**CLUTCHTECH**

**TSB-248  
Flywheel Resurfacing**

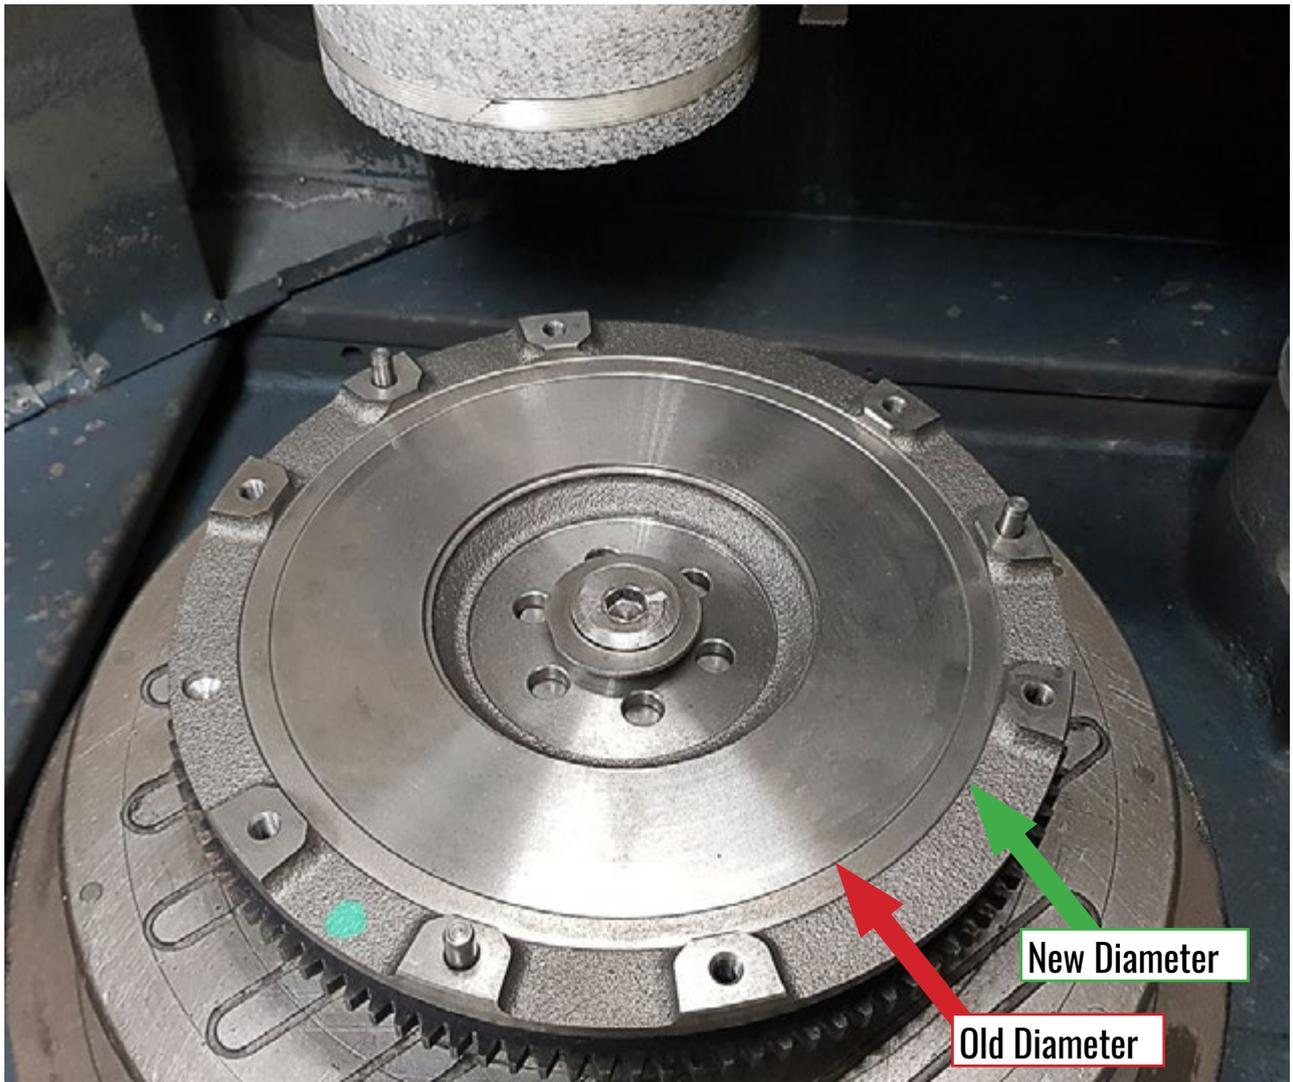
The clutch kit supplied for this vehicle is slightly larger than the original unit. It is therefore mandatory that the flywheel friction surface gets resurfaced to the outer edge of the step as illustrated in the image below. The flywheel step needs to be 7.5mm (0.295”).

Failure to do so will affect the performance and life of the clutch.
